Liberty Knitwear Co. Ltd. (9501)

27.MARCH.2014

Identified Priority 1 Concerns

1st Priority 1 Concern

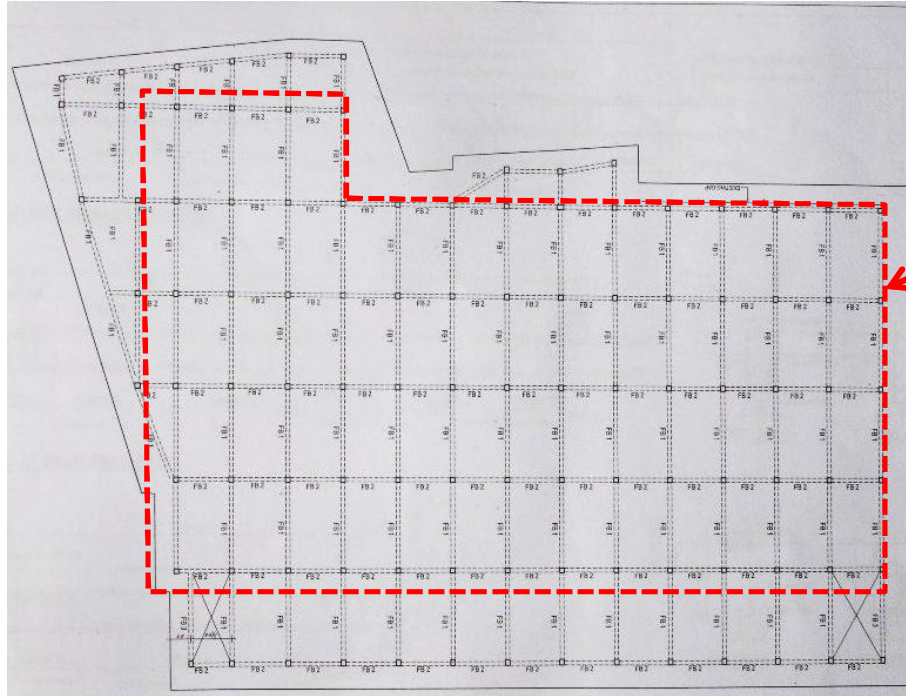
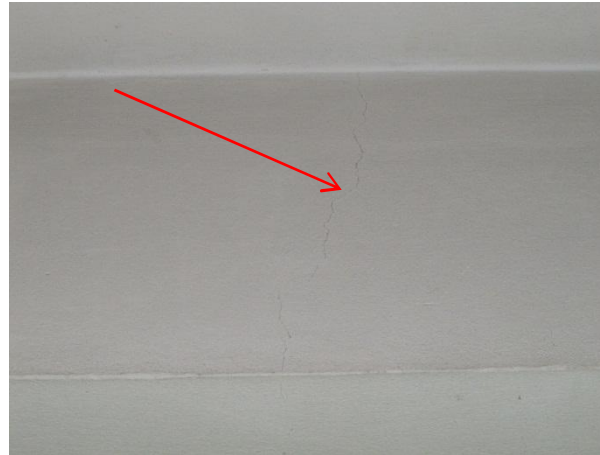
Cracks in beam - capacity check is required

The cause of cracks occurred on long span beam as shown on 4th floor plan seems to be from uncontrolled heavy load.

Cracks appeared along slab soffit and beam, capacity check is required prior to repairing.

- Request the detail engineering assessment of factory to be carried out and a suitable method of repair is to be established.
- Simply plastering over is not allowed.

2nd Priority 1 Concern

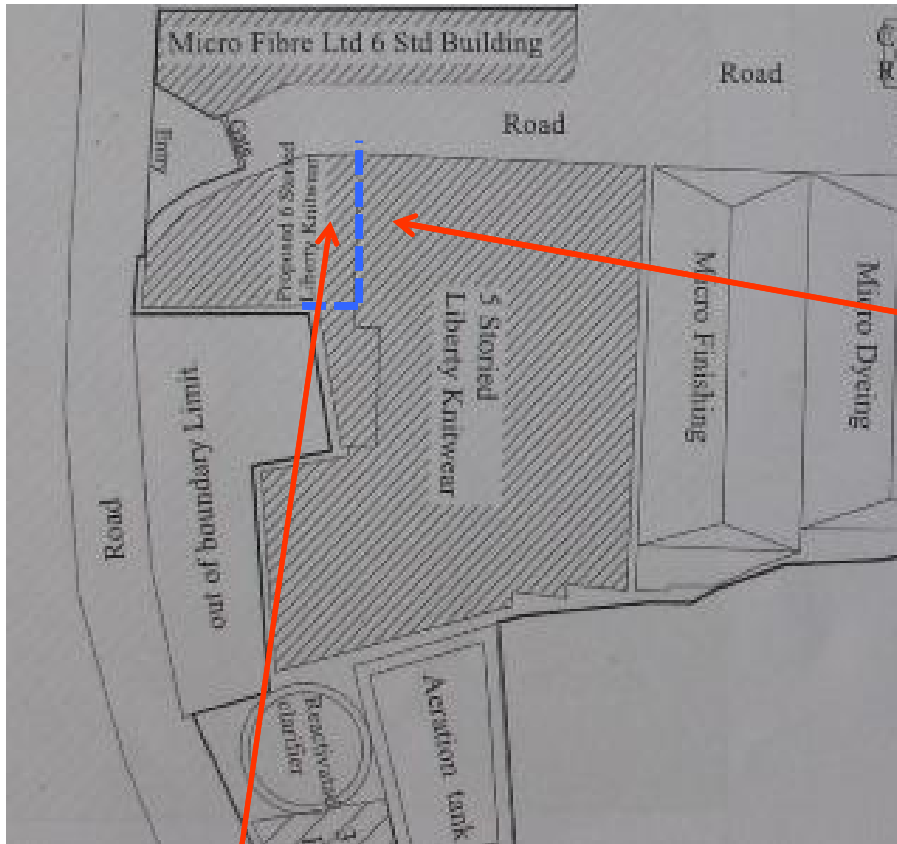
Uncontrolled Heavy Storage Loading

Uncontrolled heavy storage on 4th floor. Reduce stacking height of storage to ensure total load does not exceed 3.0kPa.

- Reduce stacking height of fabric rolls to ensure total load does not exceed 3.0kPa.

- Adopt some sort of signage/staff guidance to ensure that the maximum weight of storage is not exceeded.
- Produce an allowable loading plan for each level.

3rd Priority 1 Concern

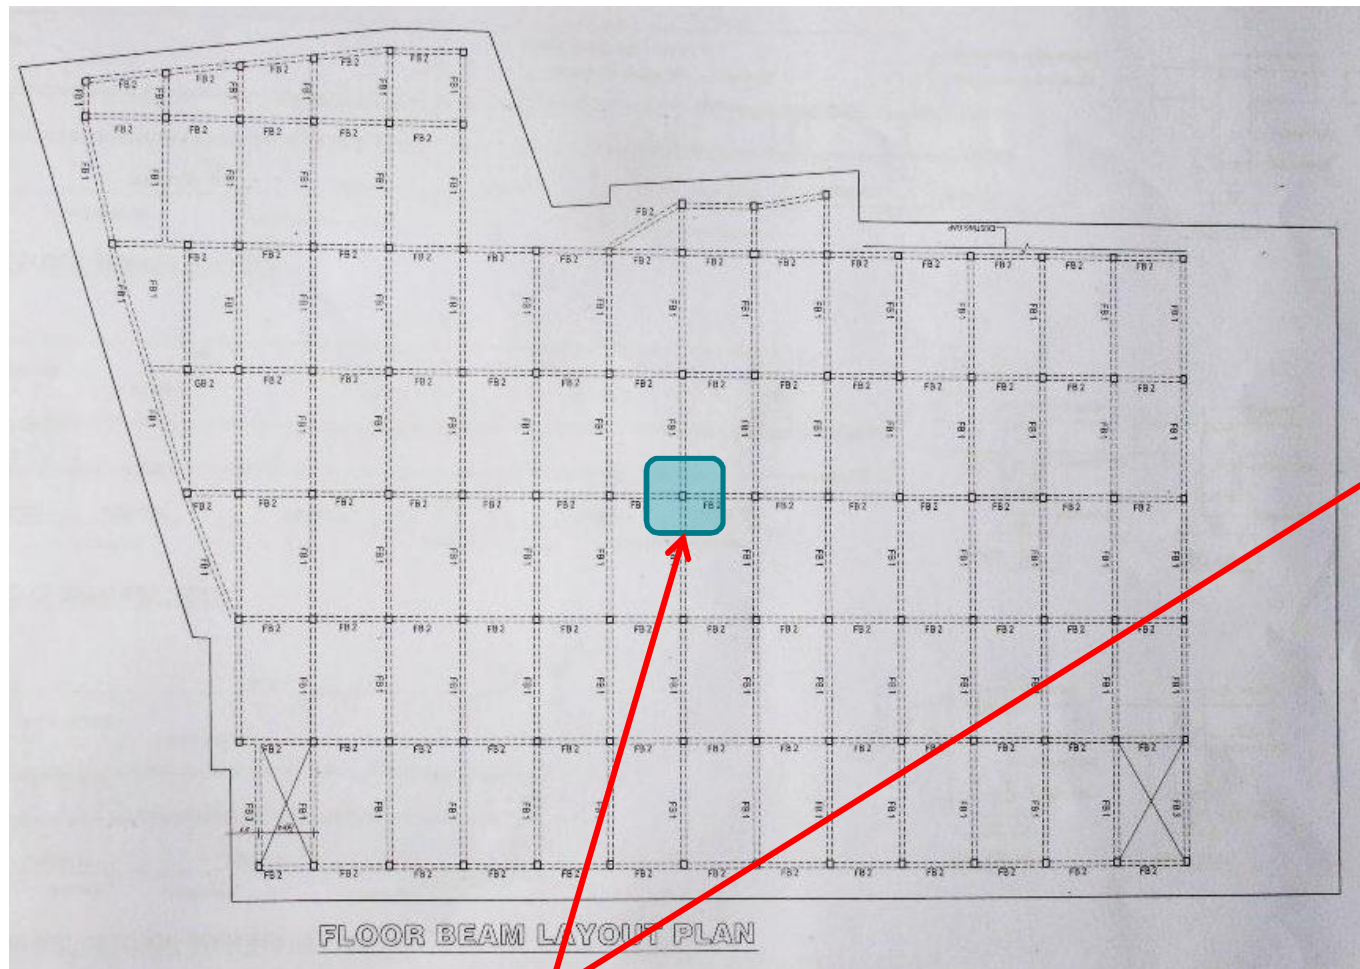
No movement joint properly established
to separate Building 1 and Building 2

----- Movement joint to be established properly

No movement joint established properly to separate building 1 and 2. Building assessment including column and foundation capacity checks are required.

- Construct a freely moveable and unrestricted movement joint between the two buildings at each level.

1st Priority 2 Concern

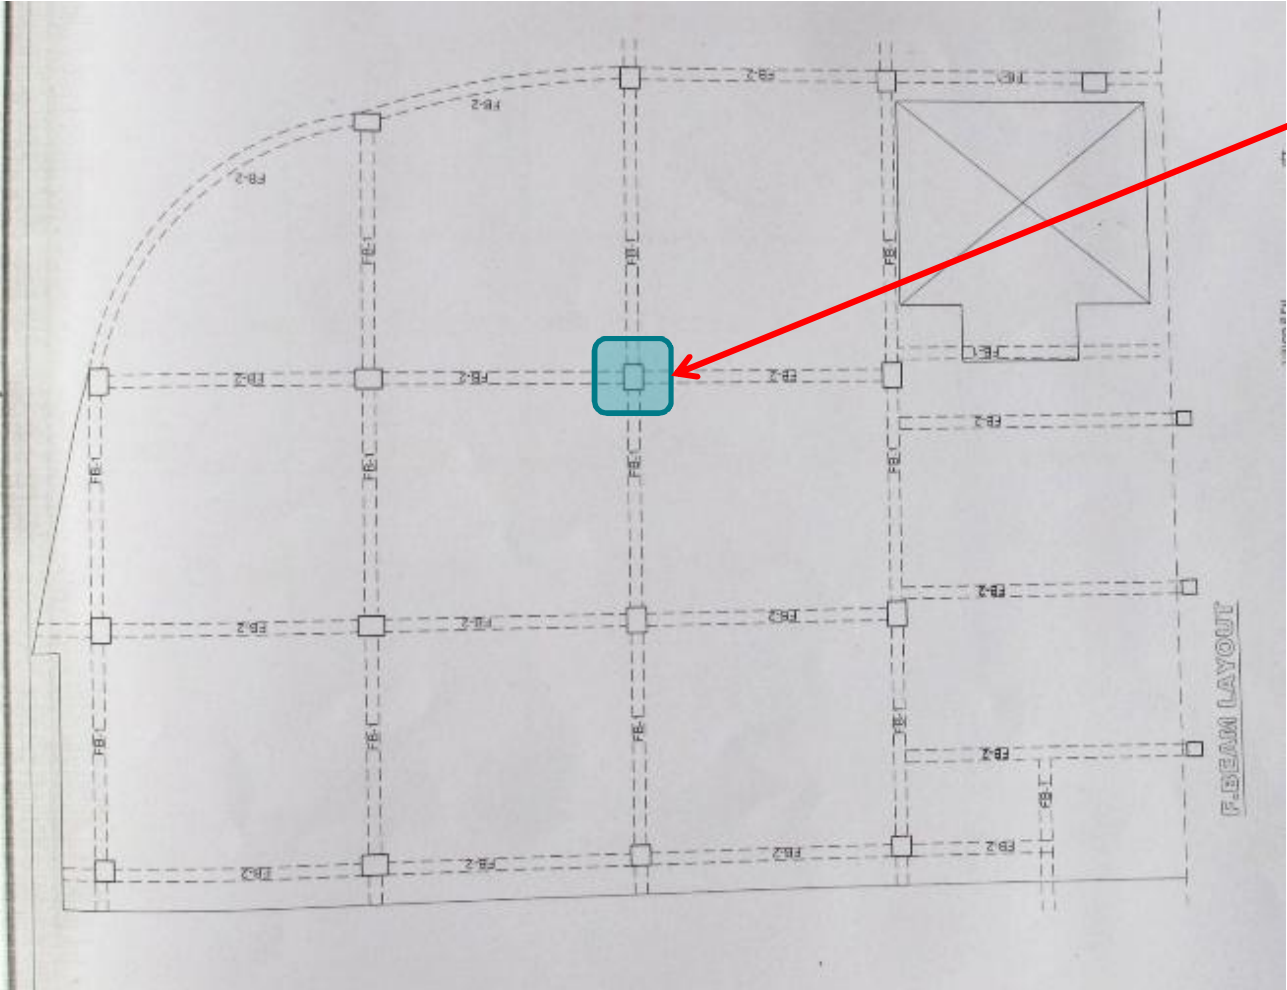
Key Steel Column Check for Building 1:

Load rundown at the key concrete column; it is found that the column stress is within the range of FoS between 1.50 and 1.86 which is a '**YELLOW**' rating.
